NAME *Stl Se* "QUEENSBURY"

No. *17886*

marks of the Chief Ship Surveyor are desired on this case for the consideration of the Classing Committee.

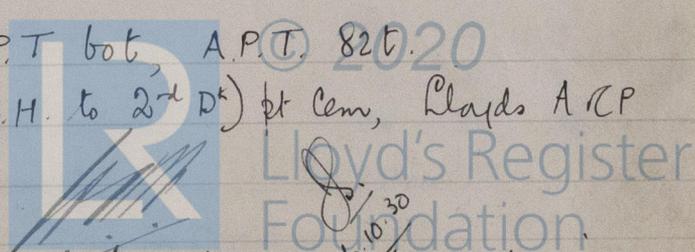
*is concluded the riveting of the butts of the upper deck sheerstrake is as
proved but the Surveyor should be requested to state if this is so.*
